## ADDENDUM 1

ITB TDD 49-19

Emerald Coast Convention Center

Restroom Renovations and Meeting Room Counters

SK-1: Clarification to detail 3/A600 to supplement R29.

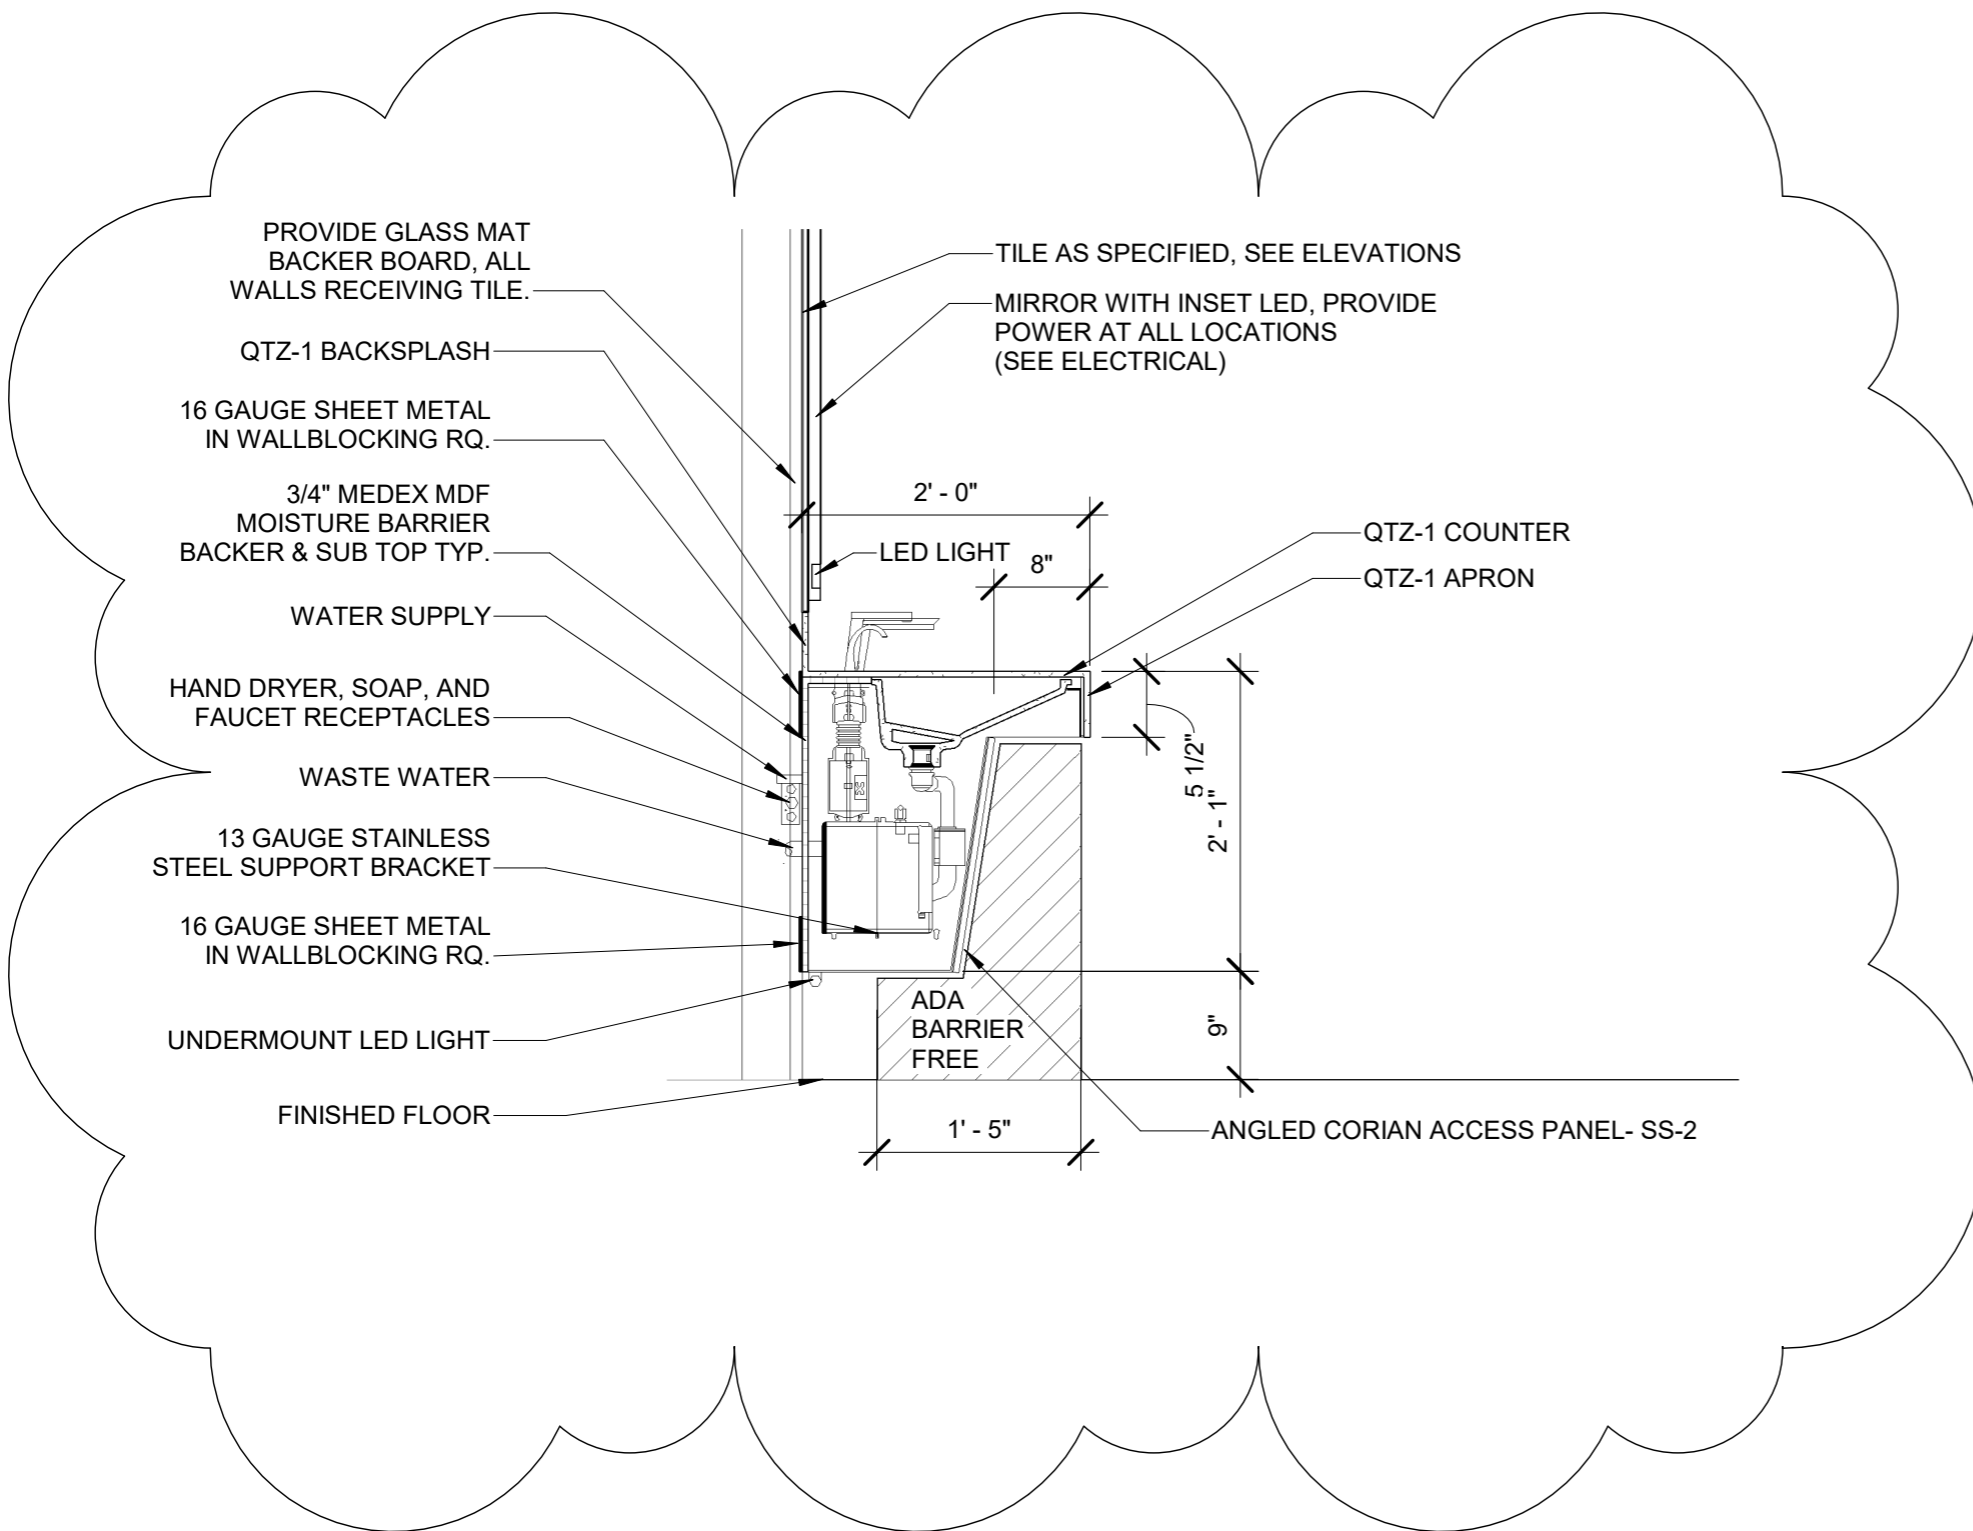
Q29. Where does 'SS-2' install?

*R29. This is a part of the sink system. There are sliding access panels at each sink. These are made from this solid surface material. This material is shown (when used) as keynote 10.4 or on the detail section vanity as Corian access panel. (see SK-1, attached)*
